ADDENDUM 2			
PROJECT:		THALES CLAYTON #4	
ADDRESS:		109 SE FLOWERS PARKWAY, CLAYTON, NC	
DATE ISSUED:		2/24/25	
ADDENDUM #	ITEM #	ITEM DESCRIPTION	RESPONSE
1	1	OWNERS' NOTE	UPDATED CUT SHEETS FOR GRAVITY VENTS TO BE INSTALLED AT EXISTING K5, HIGH SCHOOL AND GYM.
	2	DOES THIS BUILDING CONNECT ANY OTHERS VIA CONDUIT?	YES. THERE IS CAMERA FIBER RUNNING AROUND THE PERIMETER OF THE SITE. PLAN IS TO USE ONE OF THE CAMERA POLES THAT WILL BE DEMO'D AND TIE IN OFF THAT PULL BOX.
	3	WHERE WILL THE NEW TRANSFORMER BE LOCATED?	PLAN EAST, ACROSS THE DRIVE ISLE FROM THE BUILDING. SEE ATTACHED.
	4	WILL ANY NEW SITE LIGHTING BE INSTALLED? DEMO PLANS SAYS TO RELOCATE	YES. (4) LIGHTS ARE TO BE DEMO'D AND (6) ADDED AROUND DRIVE PERIMETER. SEE ATTACHED.
	5	WOULD IT BE OKAY TO POUR HANDICAP SPOTS IN CONCRETE IN LIEU OF ASPHALT?	YES, OK TO SUB FOR CONCRETE.
	6	WHAT WILL THE TRAFFIC PATTERN BE DURING CNSTRUCTION?	THERE MUST BE NO INTERRUPTIONS TO SCHOOL OPERATIONS. PLEASE SUBMIT PHASING PLAN FOR APPROVAL.

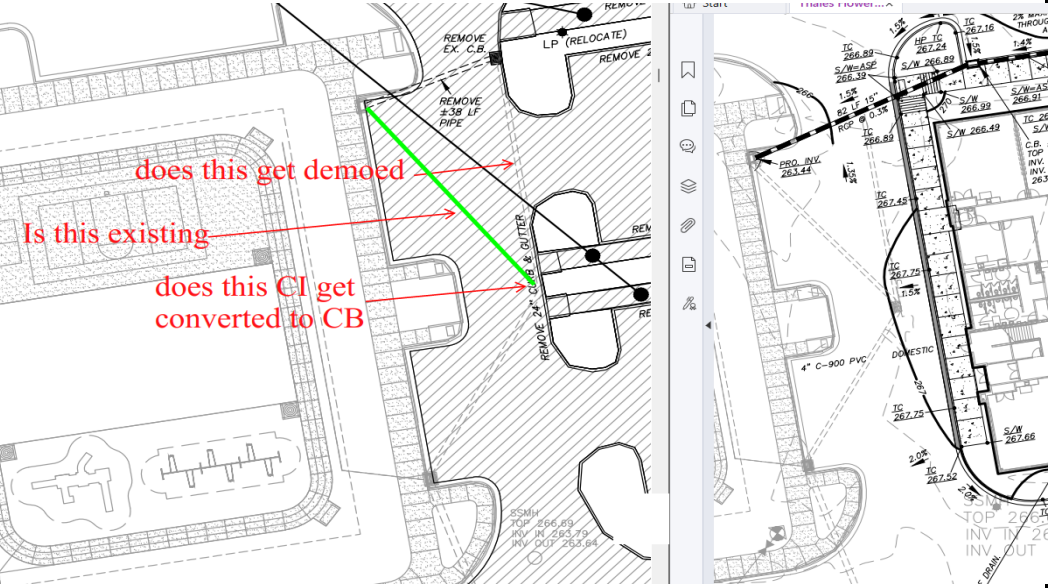
PLEASE CLARIFY THE EXISTING STORM PIPE.

This pipe “does this get demoed” – it does not exist. Shown in error on the survey/demo plan. The GREEN line is correct/ the one in the field. Do not disturb the GREEN line. No. Convert to JB. Solid Round top is fine. No need to be CB.
